ZAYO'S PRINEVILLE TO RENO PROJECT

CPUC MINOR PROJECT REFINEMENT FORM

RFI 450

VIEWPORT - 72

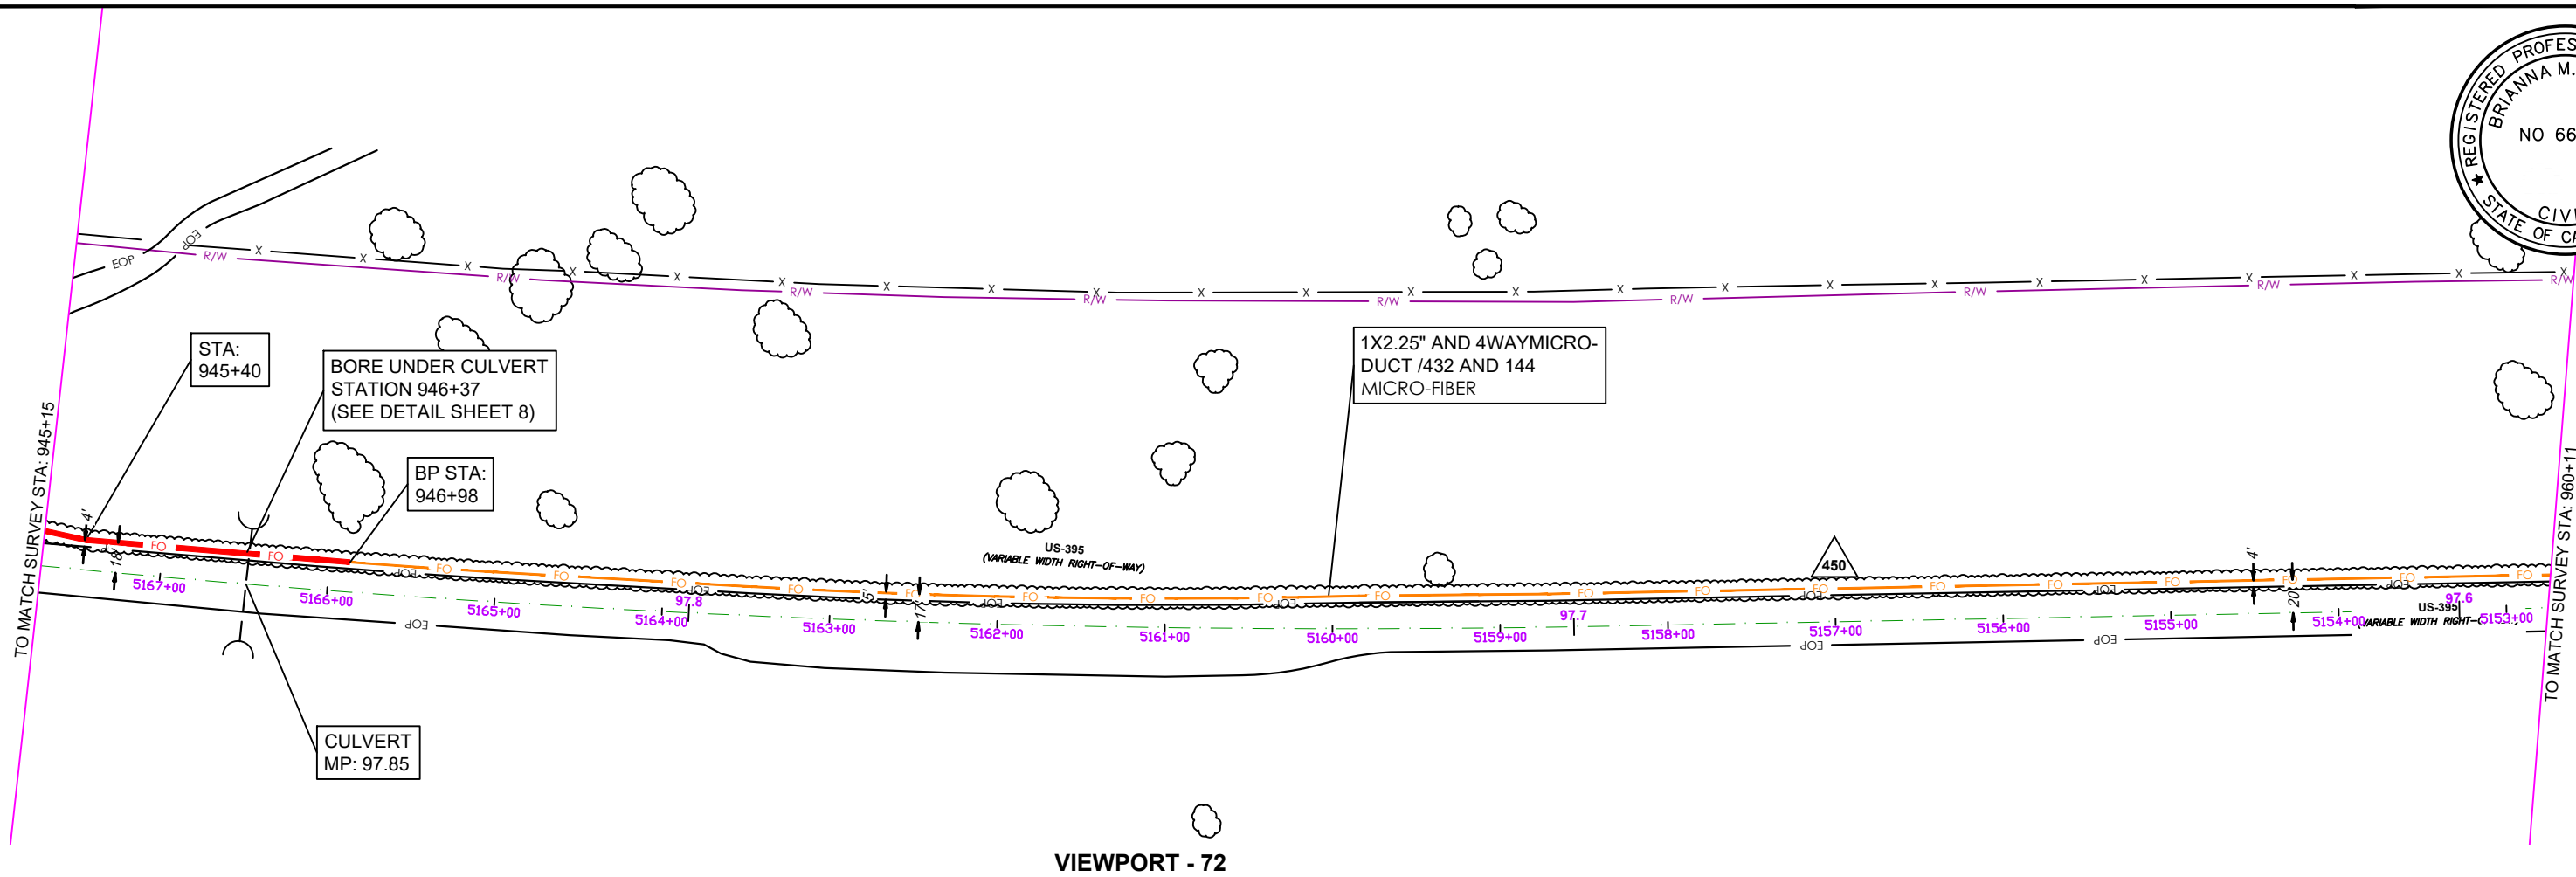
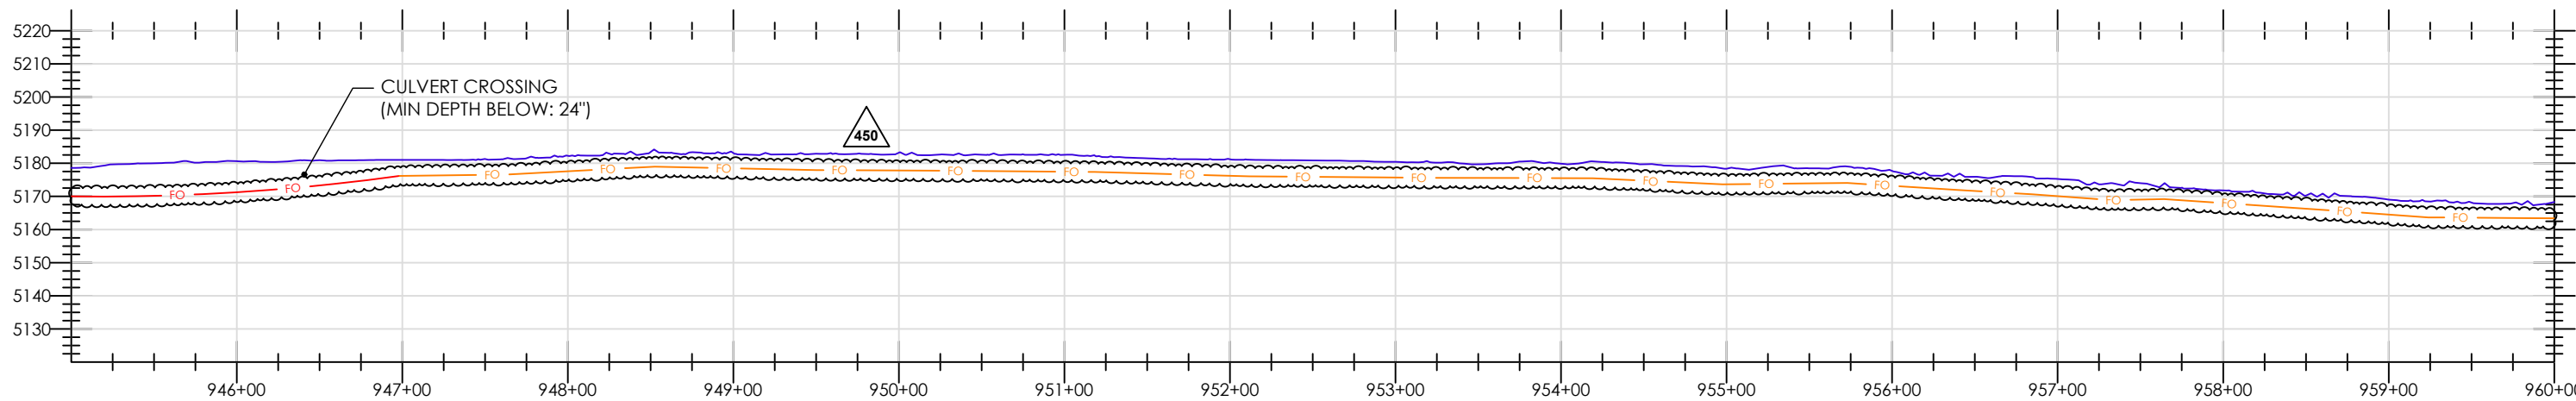
NOTES: FOR TRAFFIC CONTROL REFER TO 2023 CALTRANS STANDARDS AND LATEST EDITION OF CAMUTCD CAUTION RIGHTS-OF-WAY ARE DEPICTED BASED ON LATEST DOT RECORDS AVAILABLE. IF FURTHER ACCURACY IS REQUIRED, LAND SURVEYS WILL BE NECESSARY	RFI NO. 0450 DEVIATE R/L TO 10' FROM EOP OR TOE OF SLOPE STA 900+04 TO 905+88	12/16/2024

VIEWPORT - 73

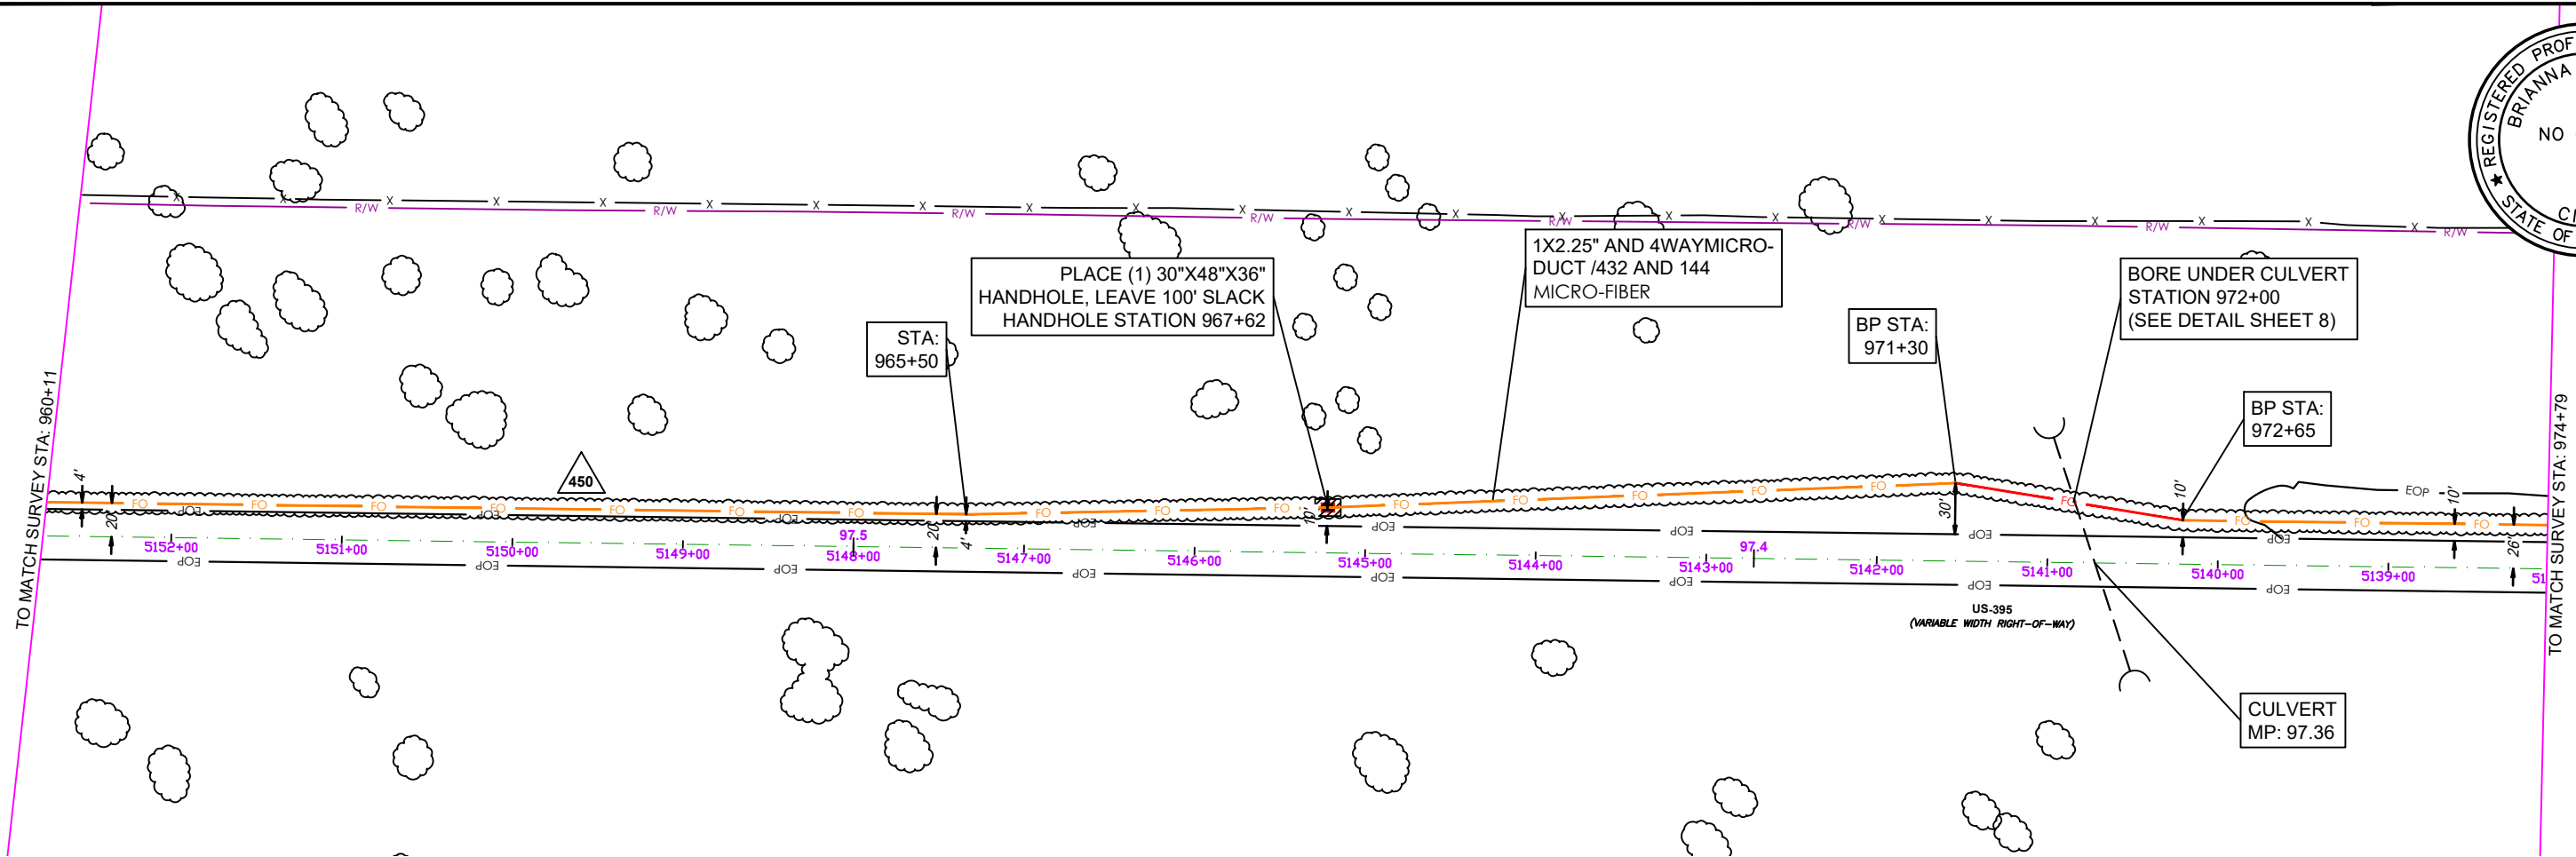
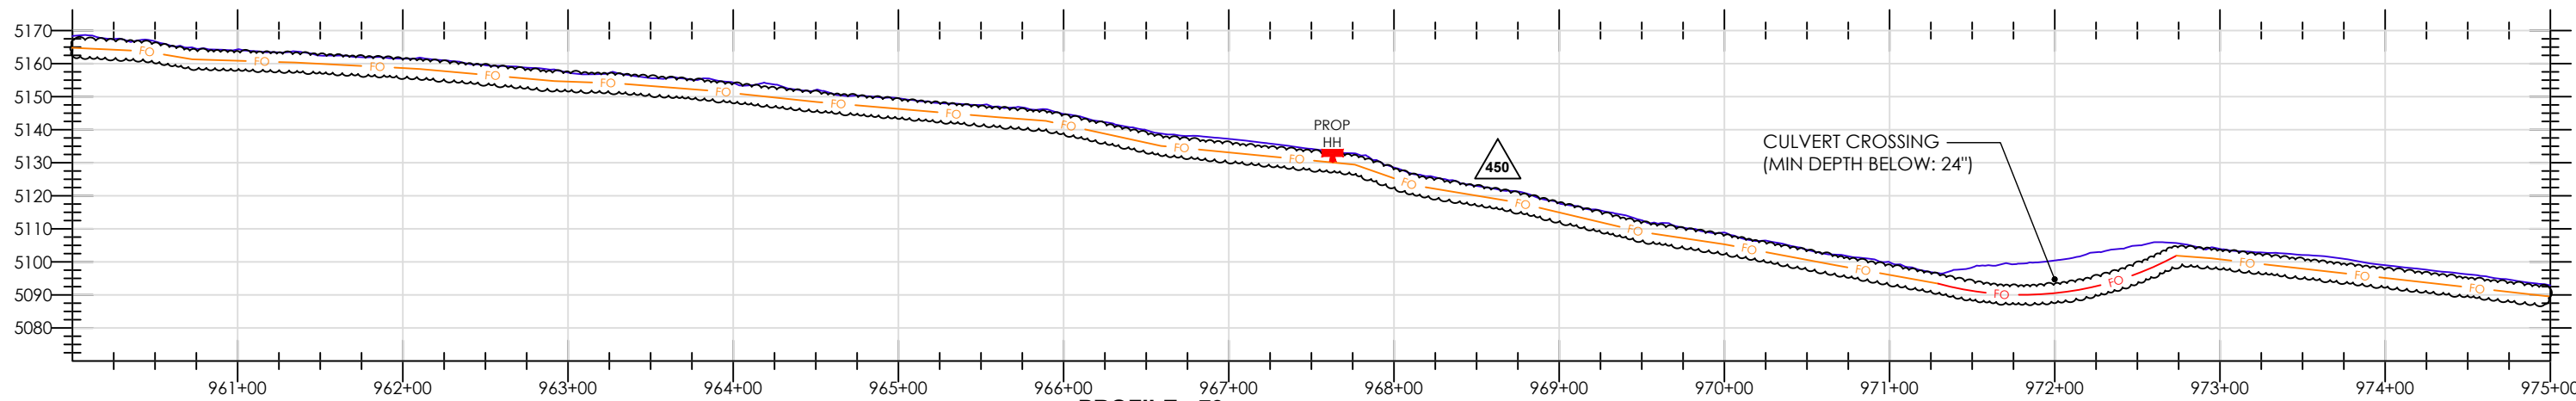
NOTES: FOR TRAFFIC CONTROL REFER TO 2023 CALTRANS STANDARDS AND LATEST EDITION OF CAMUTCD CAUTION RIGHTS-OF-WAY ARE DEPICTED BASED ON LATEST DOT RECORDS AVAILABLE. IF FURTHER ACCURACY IS REQUIRED, LAND SURVEYS WILL BE NECESSARY	RFI NO. 0450 DEVIATE R/L TO 10' FROM EOP OR TOE OF SLOPE STA 900+04 TO 905+88	12/16/2024

VIEWPORT - 74

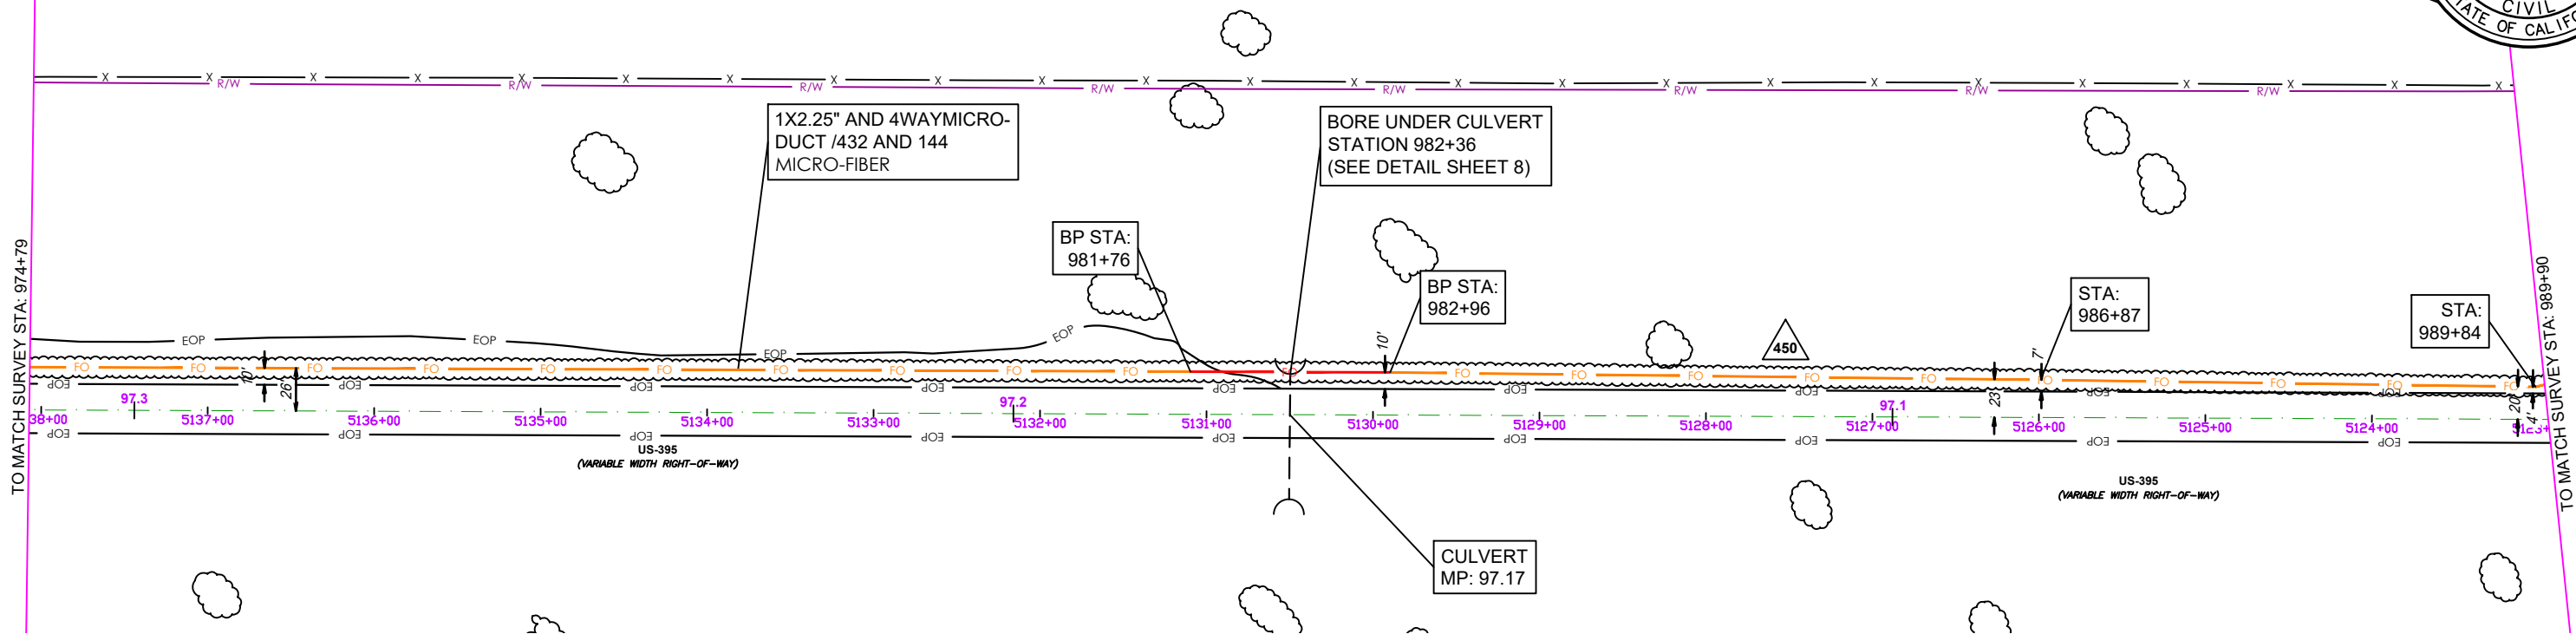
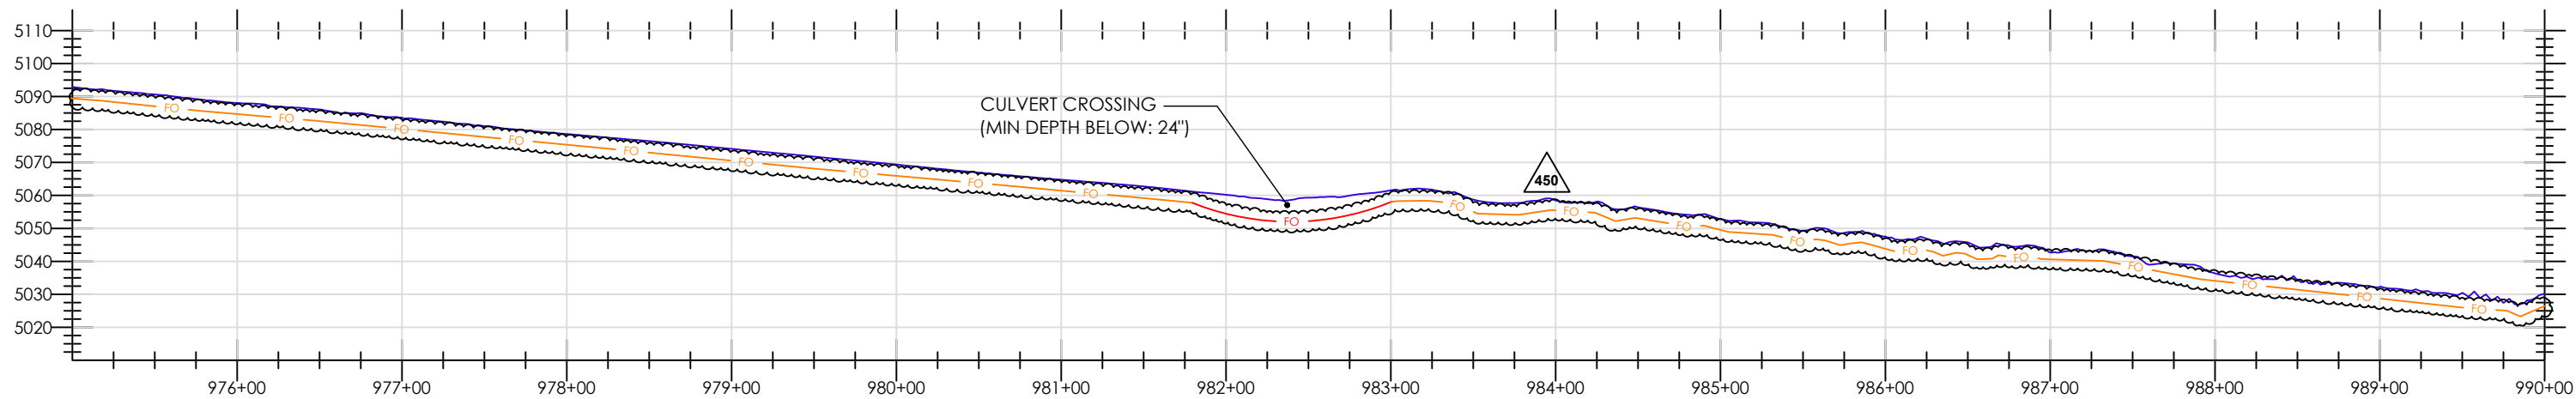
NOTES: FOR TRAFFIC CONTROL REFER TO 2023 CALTRANS STANDARDS AND LATEST EDITION OF CAMUTCD CAUTION RIGHTS-OF-WAY ARE DEPICTED BASED ON LATEST DOT RECORDS AVAILABLE. IF FURTHER ACCURACY IS REQUIRED, LAND SURVEYS WILL BE NECESSARY	RFI NO. 0450 DEVIATE R/L TO 10' FROM EOP OR TOE OF SLOPE STA 900+04 TO 905+88	12/16/2024
